### **MEMORANDUM**

**TO:** Town of North Castle  
**FROM:** Eliot Senior P.E. L.S.  
**SUBJECT:** 1 Guion Lane  
**DATE:** August 7, 2023

**DRIVEWAY GRADING  
 DRIVEWAY PROFILE  
 DRIVEWAY SIGHT DISTANCE**

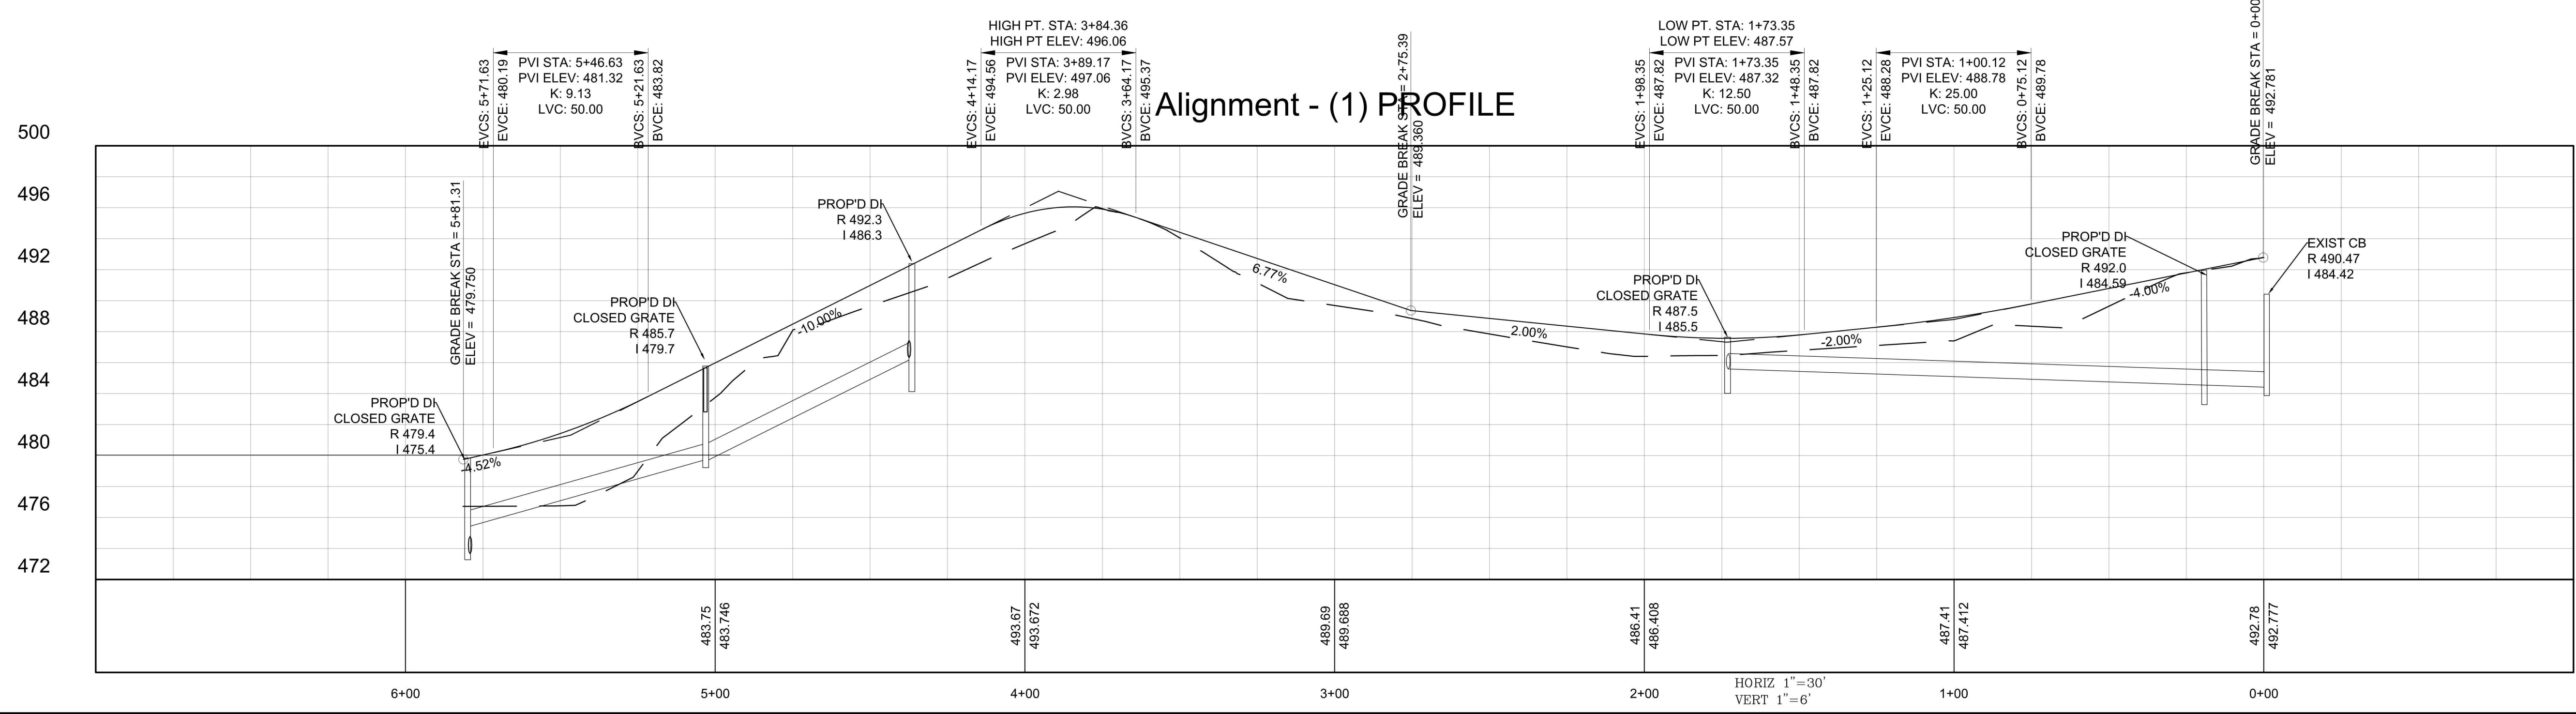
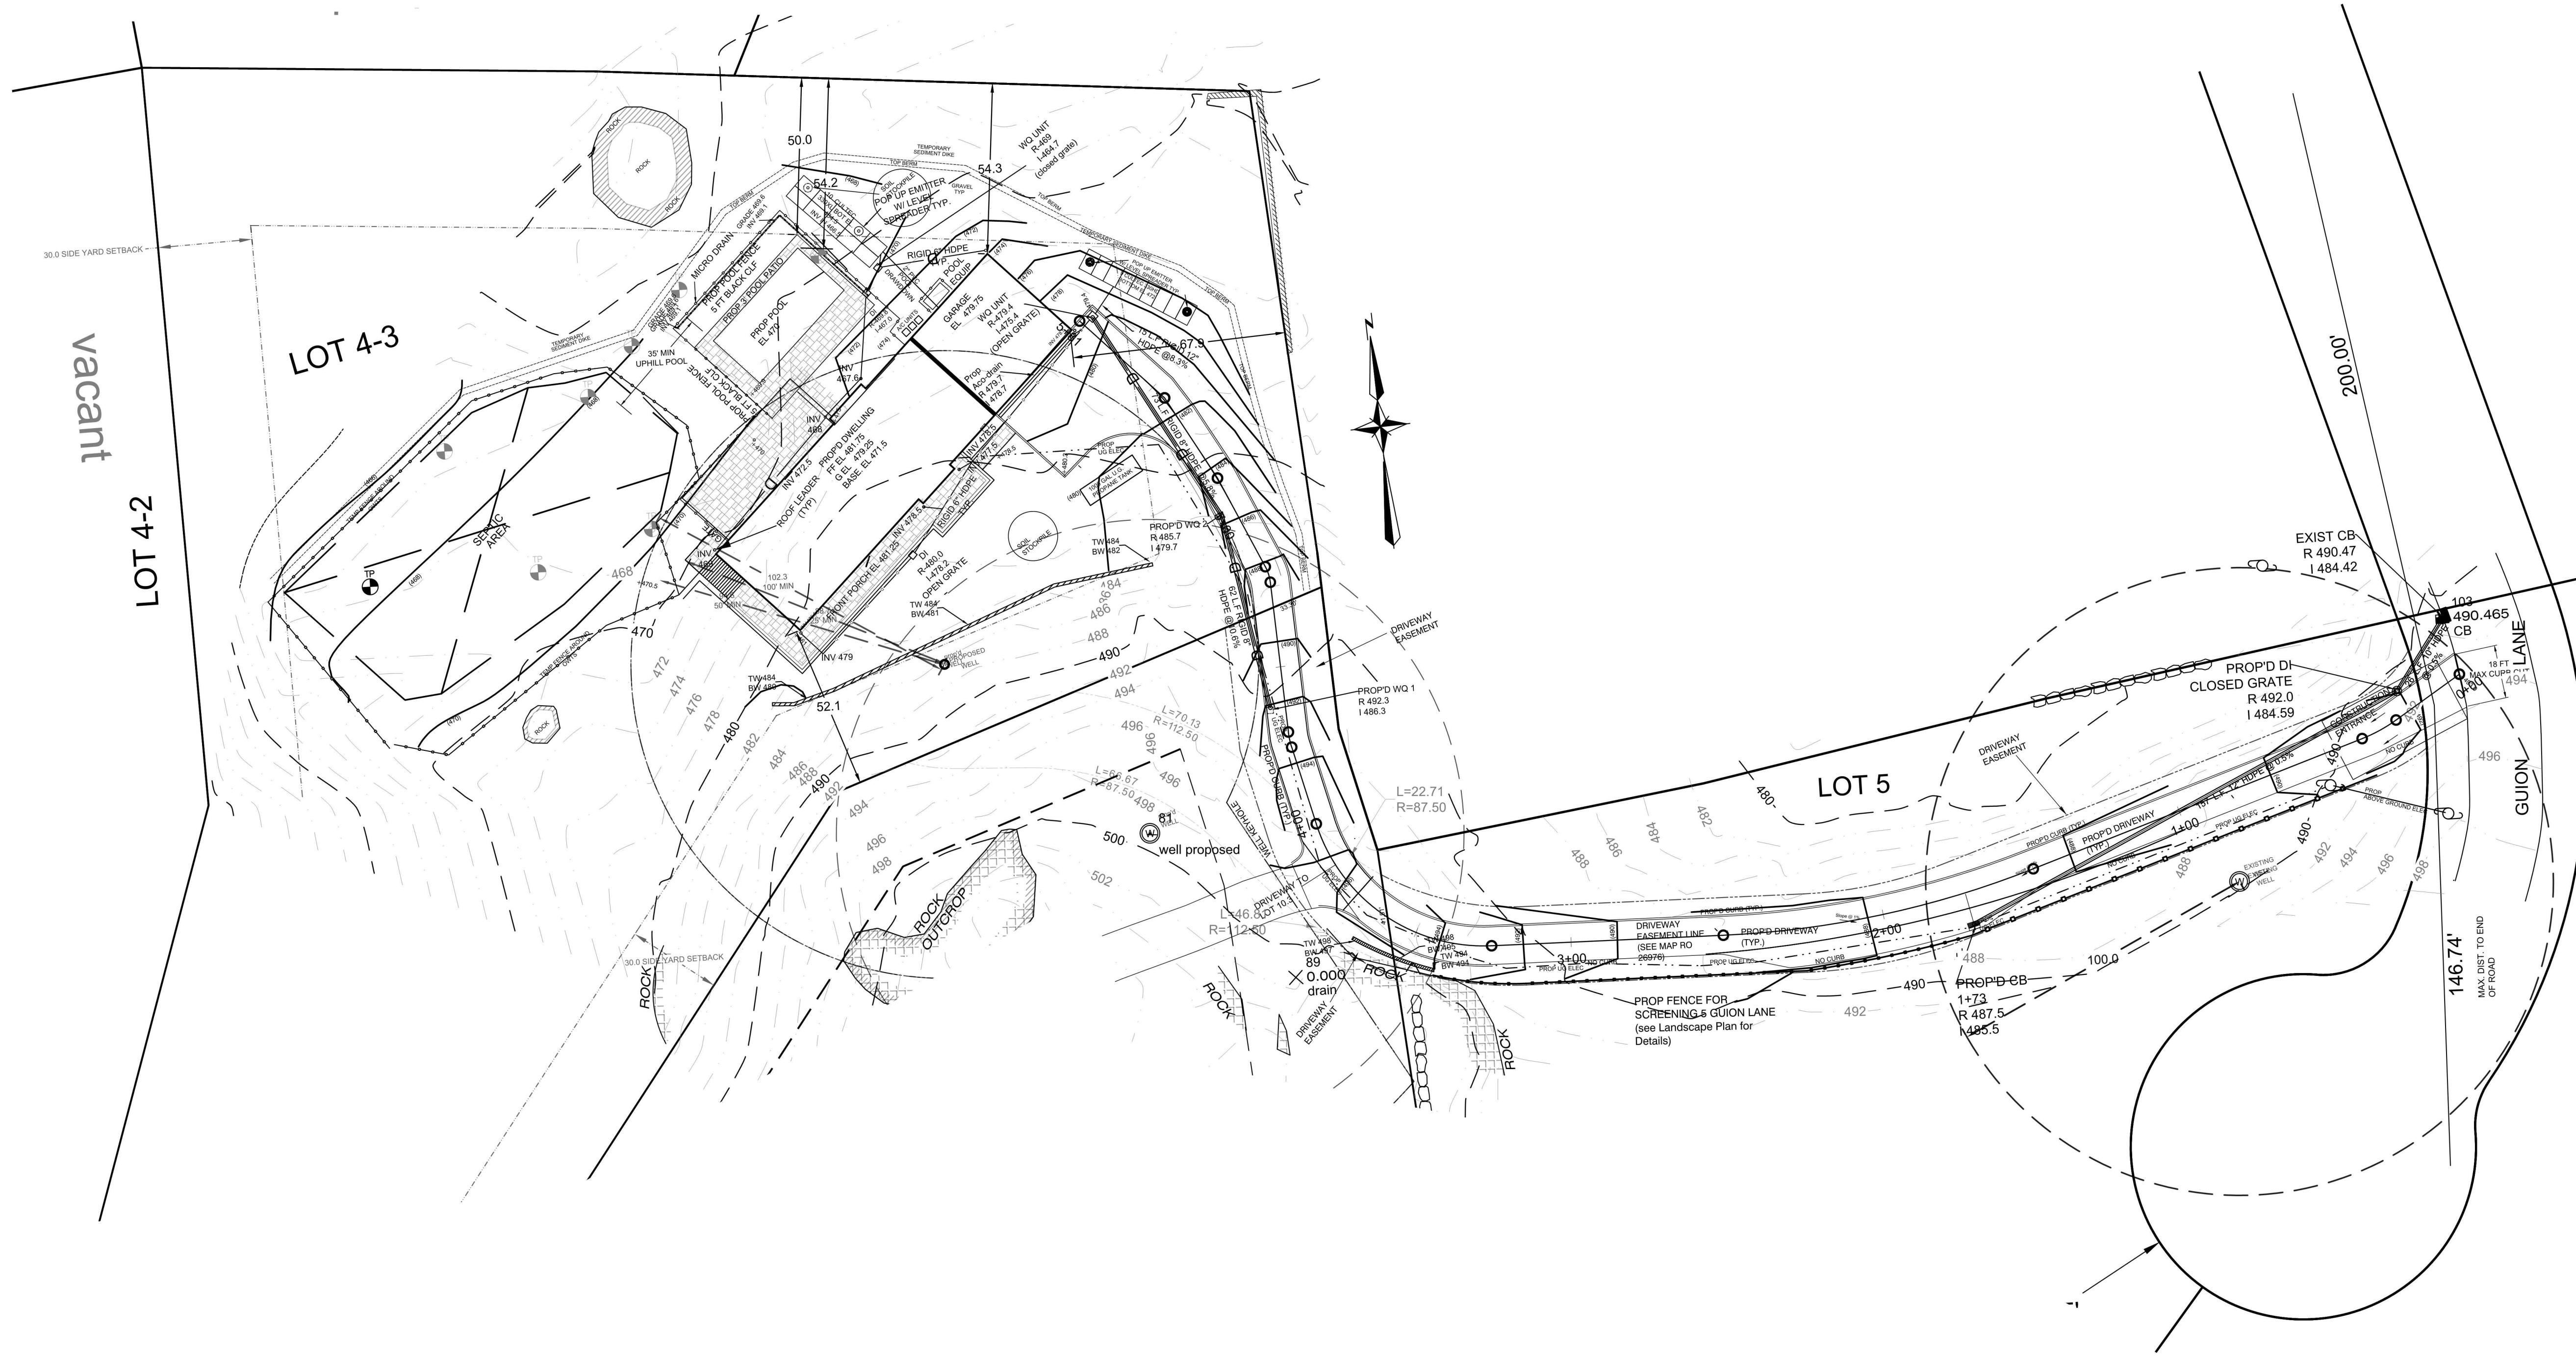
2. A driveway profile is provided on Sheet SW-4. The profile should provide the K Value at each vertical curve and the applicant should explain the design volume he is trying to obtain for the curves. Vertical curve at Station 4 + 70 ± appears to provide limited sight line over the crest. A much larger vertical curve seems appropriate.

***Vertical curve has been made larger to provide better sight line distance over curve.***
